BULLETIN 186-001 286-001 NO. 386-001

SUBJECT: TECHNICAL SERVICE BULLETIN LISTING

1985 TECHNICAL SERVICE BULLETINS

SUBJECT: 3-SHOE UNLINED CLUTCH ASSEMBLY

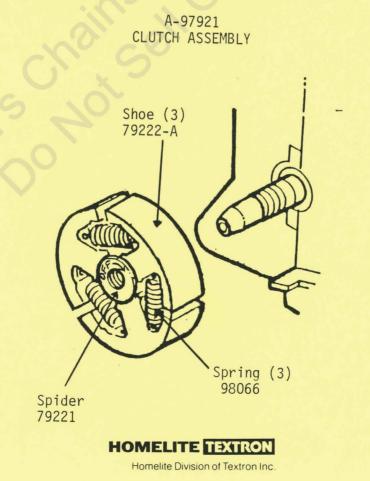
The one-piece "S" Clutch used on the subject model chain saws has been replaced by a three-shoe unlined clutch assembly A-97921. This three-shoe clutch should be used whenever replacing the "S" Clutch on the XL, XL-2, Super 2, and VI Super 2 chain saws.

Install the clutch assembly (left hand thread) with the counter bore in the spider facing towards the crankshaft (Refer to Technical Service Bulletin 184-009, 9/84). Torque clutch to 125 in.lbs. (14.1 Nm).

DO NOT USE the 3-shoe clutch on the ST-200 and ST-210 as it will result in lowered clutch engagement speeds. When used with the brushcutter attachment, the blade may continue to rotate at idle speed.

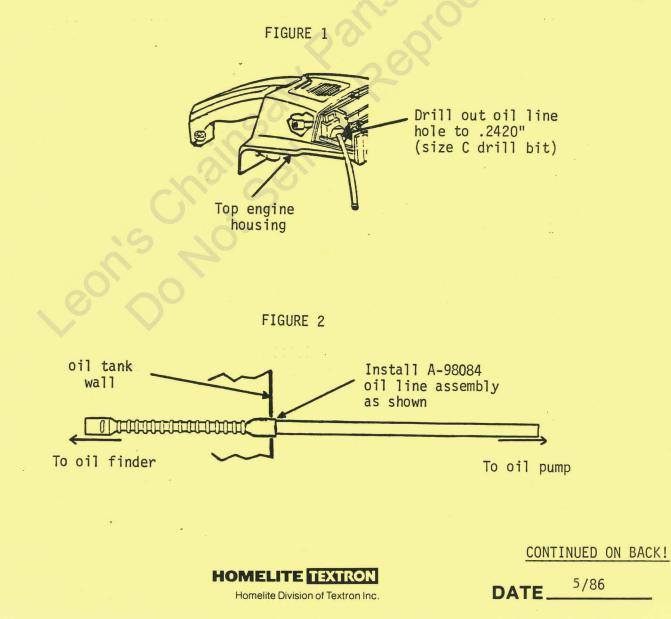
To install the A-98084 oil line in units built prior to Lot #G305, remove the existing oil line (70309-26) and drill out the oil tank hole to .2420" using a size "C" drill bit (see Figure 1). Thoroughly clean the oil tank after drilling. Install the new oil line assembly as shown in Figure 2.

SUBJECT: REVISED CYLINDER ASSEMBLY (A-70489-C) WITH COMPRESSION RELEASE VALVE

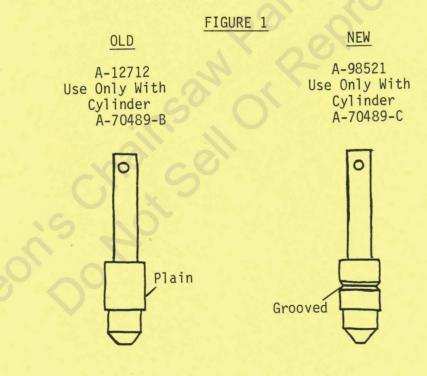
The cylinder assembly on the Model 750 Chain Saw has been revised in the area of the compression release valve. The revision was made to eliminate the valve pounding the seat resulting in cylinder bore and piston damage. Due to the compression release hole in the bore of the cylinder being made smaller, the new cylinder assembly (A-70489-C) requires and includes a revised compression release valve assembly (A-98521).

In order to insure proper seating, the new compression release valve (A-98521) must be used with the new cylinder (A-70489-C). The new valve can be identified by a "V" groove as shown in Figure 1 below.

SUBJECT: 1) NEW, STRONGER 32ME SERIES (.325) SAW CHAIN 2) MODIFYING GUIDE BAR ADJUSTING PIN 69254-1A

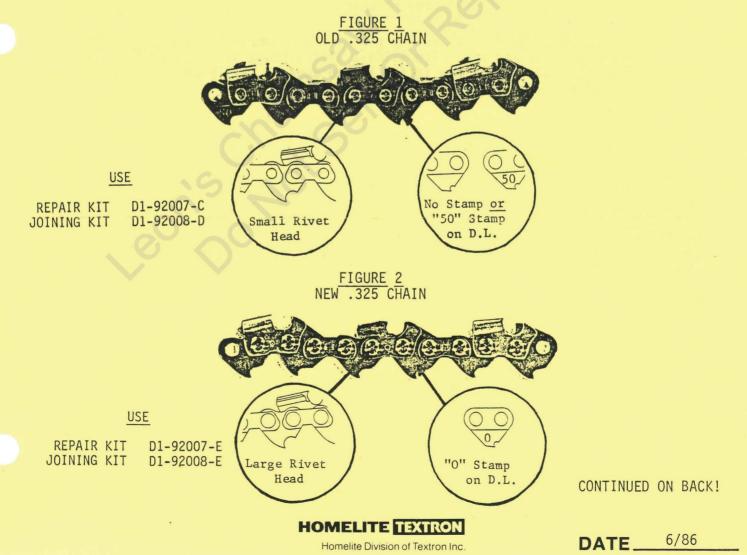
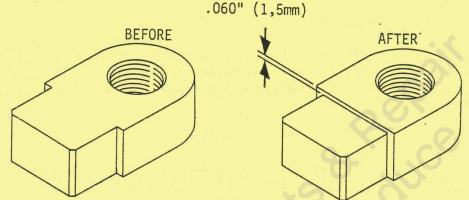
The 32ME Series (.325) saw chain has been made stronger by increasing the diameter and length of the rivet. This improvement required larger holes in the drive links, tie straps, and cutters, therefore the repair and joining kits SHOULD NOT BE interchanged.

The new, stronger chain can be identified by larger rivet heads and "O" stamped on the drive link. Refer to FIGURE 1 (OLD CHAIN) and FIGURE 2 (NEW CHAIN) below when identifying saw chain and ordering service kits.

2) When installing the new, stronger 32ME50-67 (67 drive link) chain with the PT-16321-G4 guide bar on the Model 245 (or 240 with .325) it may be necessary to file .060" (1,5mm) off that section of the adjusting pin which fits into the guide bar. Refer to Figure 3 below. Reinstall the adjusting pin into the drivecase cover with the step (the side which was filed) facing TOWARD THE FRONT of the saw.*

The current 69254-1A adjusting pin will be superseded by a universal 69254-2 adjusting pin. The 69254-2 will already have the .060" step. When installing this pin in the XL and Super 2 family chain saws, put the step facing TOWARD THE REAR of the saw.

FIGURE 1

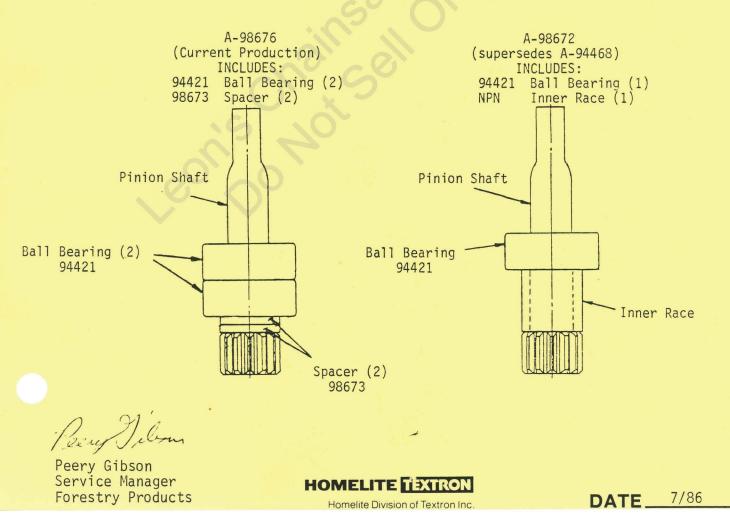
A one-piece pinion shaft and cut gear has replaced the two-piece pinion shaft assembly in the ST-200 brushcutter attachment.

Service will supply two pinion shaft assemblies (see FIGURE 1 below) to service both the NEW and OLD brushcutter kits.

A-98676 Pinion shaft with two ball bearings to service brushcutter kits built AFTER the LOT dates shown above.

A-98672 (supersedes A-94468) pinion shaft with <u>one</u> ball bearing and inner race to service older brushcutter kits.

SUBJECT: THREE-SHOE UNLINED CLUTCH A-98132

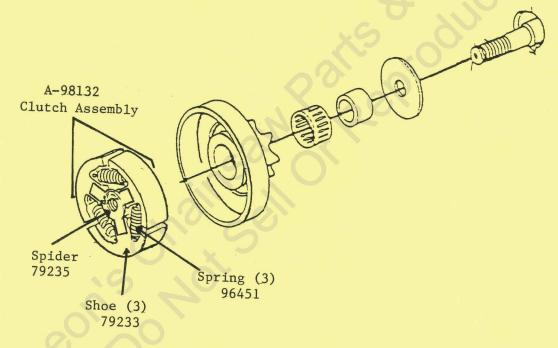
A three-shoe unlined clutch assembly A-98132 has superseded the one-piece S-clutch 68362-7 used on the subject model chain saws. Refer to the diagram below when ordering parts for this new clutch assembly.

Install clutch assembly A-98132 with the "OFF \rightarrow " facing out. Torque clutch assembly to 250 - 300 in.1bs. (28.2 - 33.9 Nm).

SUBJECT: NEW SOLID STATE IGNITION

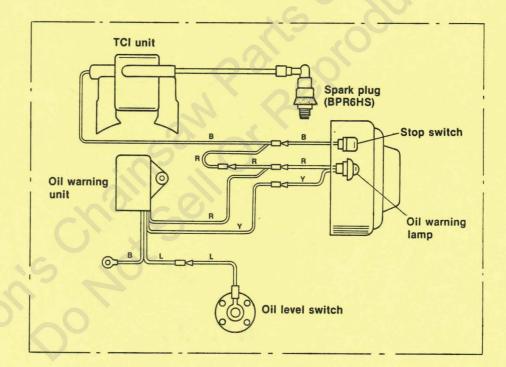
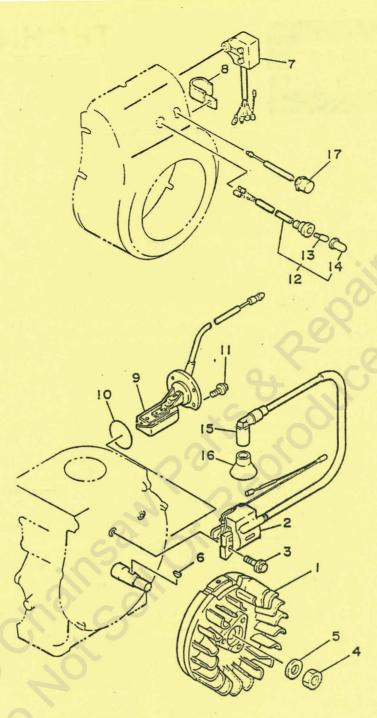
The HG1400's are now equipped with solid state ignition systems starting with Serial Number 7H6405450 and above. Below is a list of parts and part numbers for the components that make up this system and the wiring diagram.

SEAL AND IMPELLER SPACING INSTRUCTIONS

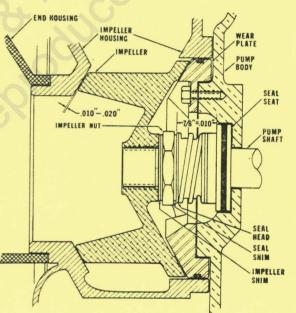
It is very important to shim the spring pressure of the seal properly when installing new seals. If the seal is not properly shimmed, it will leak and the priming ability of the pump will be very poor. Some seals have an additional shim packed with them which is normally needed for proper spring pressure.

2. Measure the distance between the seal head and seat as shown. Add or subtract shims as necessary to obtain a dimension of $7/_8$ " (± .010"), to correctly set spring pressure. Tighten the nut to 50 foot pounds torque.

3. Place impeller shims against the nut and thread on the impeller. Add or substract shims until the impeller just strikes the impeller housing when the housing is held in place. Remove one .015" shim to set correct impeller clearance. Complete reassembly of the unit.

SUBJECT: POLARITY OF BATTERY CHARGING CORD (PART NUMBER 49024-35)

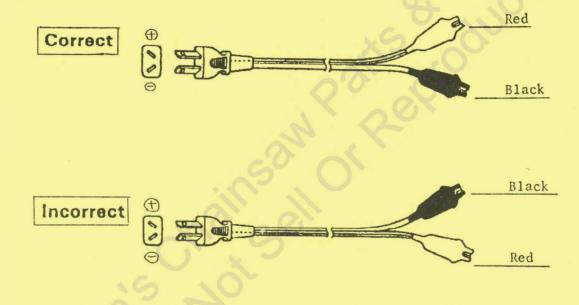
The battery charging cord (#49024-35) in units with serial numbers 7FF-000701 to 7FF-001100 may be reversed in polarity. If the charging cord you have is reversed, it will be necessary to remove and reinstall the red and black vinyl clip covers to the proper lead wire. This labor time can be covered by Warranty for 0.2 hr. per unit.

If the leads are used in reverse, the DC Circuit Breaker will trip and the DC Rectifier and Stator Coil could be damaged.
